Office Action Summary

10/080,933

DETAILED ACTION

Fig.2 of current Application

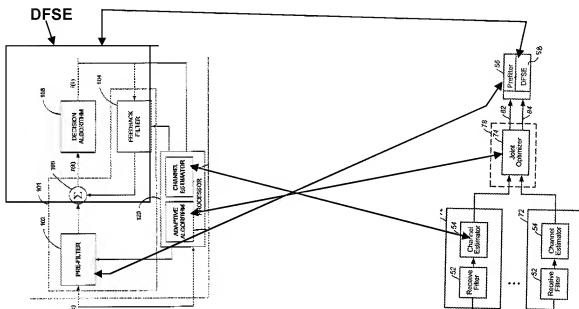
11. Applicant's arguments filed 3/19/09 have been fully considered but they are not persuasive. It is alleged that four separate structural elements are claimed while Zangi only teaches three structural elements. This is inaccurate. Examiner maintains that at least Fig. 3 of Zangi shows the corresponding claim features. As shown in the diagram below, each of applicant's claimed feature, shown, for instance in fig. 2, corresponds one to one to each of Zangi's components shown at least in fig. 3. The DFSE circuit of Zangi (see diagram below), corresponding to applicant's claimed limitation "DFSE", includes a summer 106, a feedback filter 104 and a maximum likelihood sequence estimator 108. In addition, the adaptive algorithm 124 of Zangi corresponds to signal optimizer, shown in applicant's fig. 2, as block 74. Zangi further teaches a channel estimator 122, shown in applicant's fig. 2 as 54. Zangi teaches a prefilter 102 corresponding to applicant's circuit block 56 depicted in fig. 2. Since Zangi teaches every feature of the claimed invention, i.e., structurally and functionally, as depicted in the above rejection, and further, as shown in the mapping below, Zangi anticipates the claimed invention.

With respect to the drawing, applicant stated that replacement sheet corrects the deficiencies noted in the outstanding drawing objection. However, the changes noted in the comment are not in the drawing (replacement sheet). Fig. 3 only shows the output of the optimizer being provided to the prefilter and DFSE 56/58. However, fig. 3 shows a signal 53 being provided to the prefilter. This not consistent with fig. 2.
